RE: UC-6 Inlet As-Built – Task ID# 2465, Dugout Canyon Mine, Canyon Fuel Company, LLC,
C/007/039, Carbon County, Utah

Title: UC-6 Inlet As-Built, Task ID #2465

**APPENDIX 7-9
ATTACHMENT D**

UC-1 INLET AS-BUILT

UC-6 Inlet (see note below)

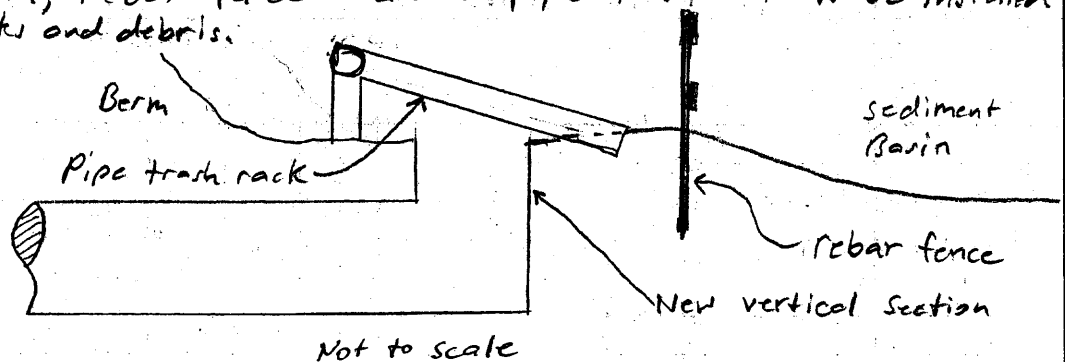
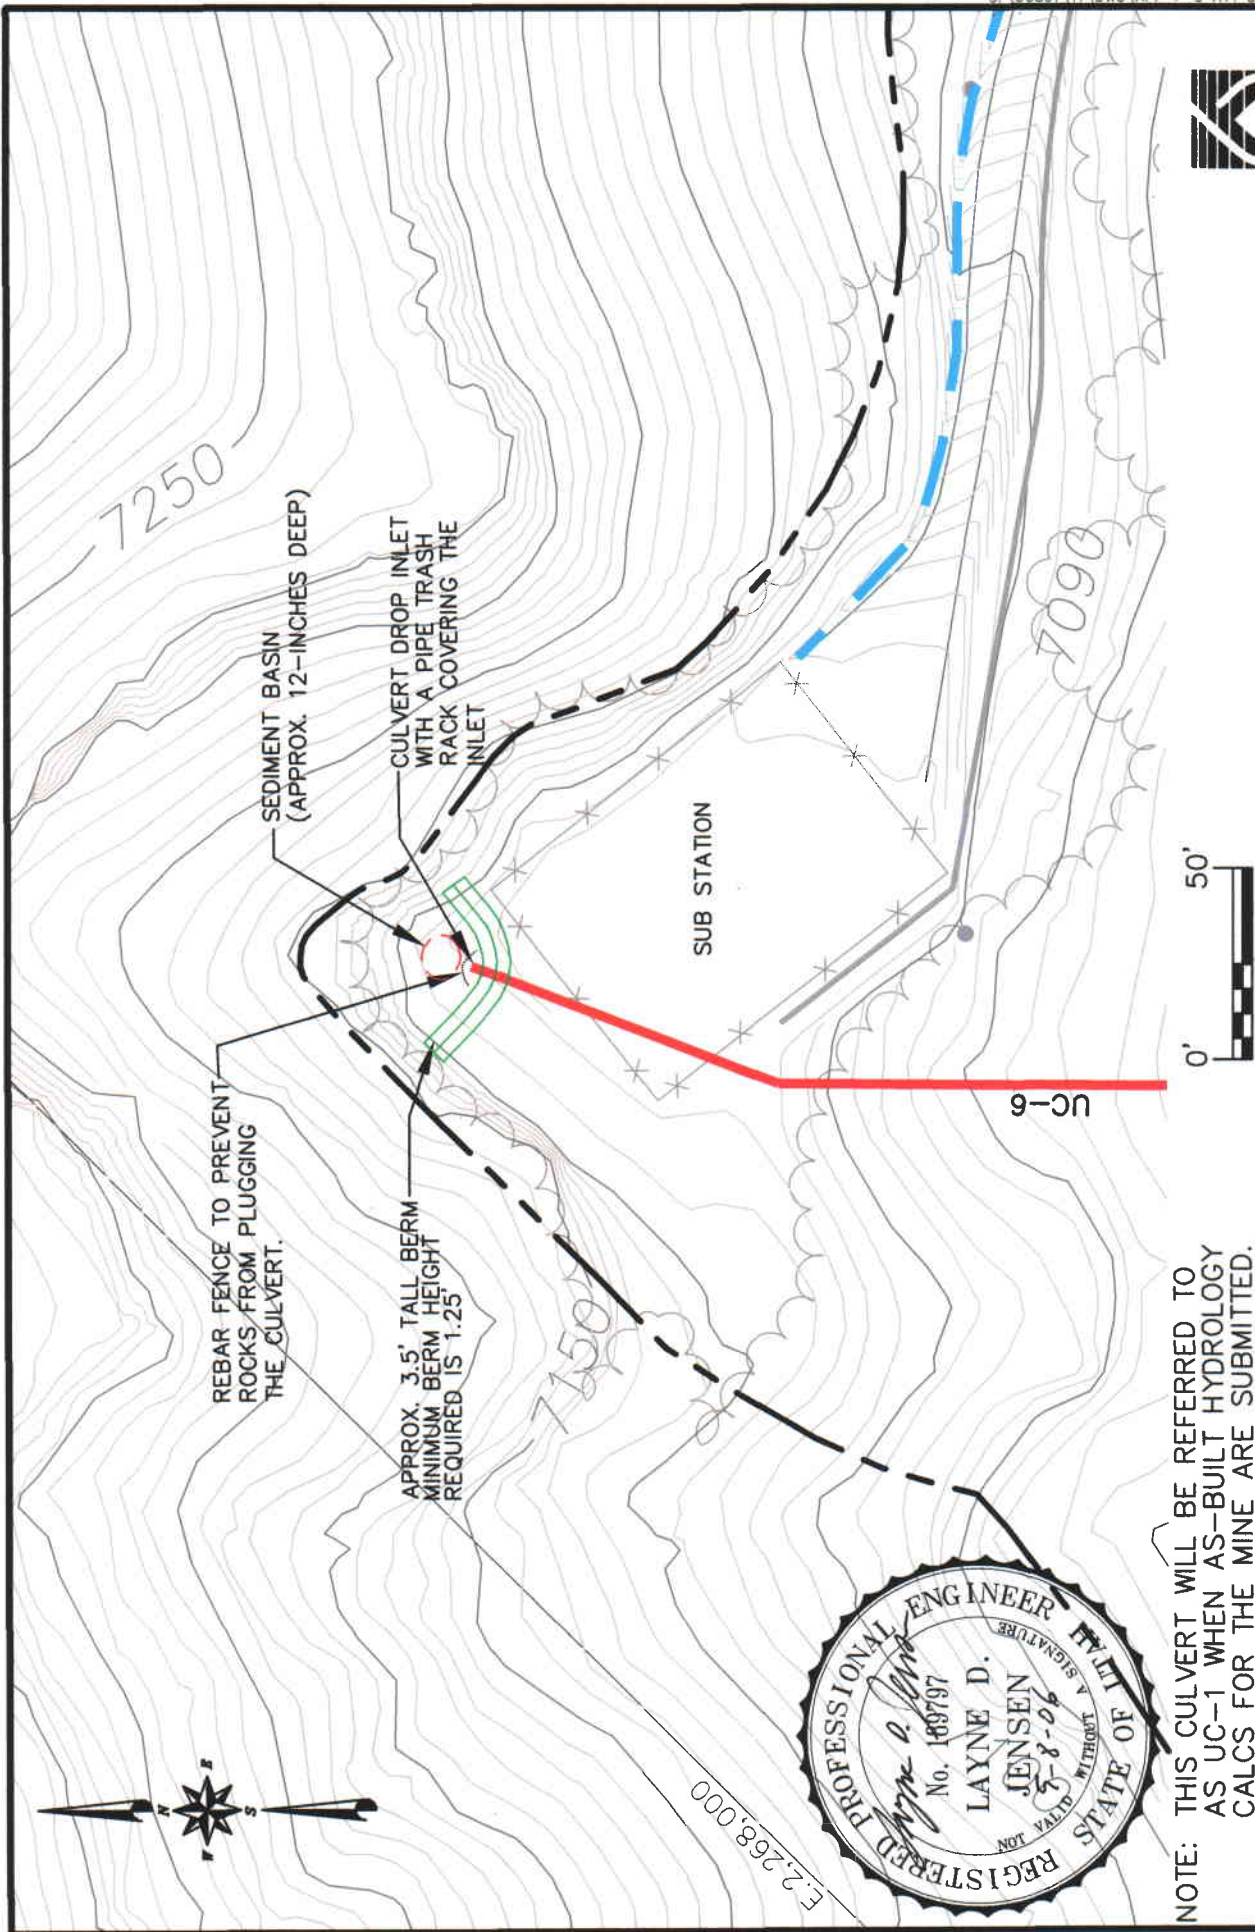
The inlet to UC-6 has been modified to prevent plugging by rocks and debris. To create space a vertical section of CMP was added to the shortened culvert. The additional space allowed for a small sediment basin, rebar fence and a pipe trash rack to be installed to stop rocks and debris.

According to Appendix 7-9 the peak flow from the 10-year 24-hour storm is 1.02 cfs.

$$H = [1.02 / (3.0 \times 4.71)]^{2/3} = 0.17 \text{ ft} = 2.1 \text{ inches}$$

To provide at least 1 foot of freeboard the berm around the inlet should be at least 14.1 inches high or 15"
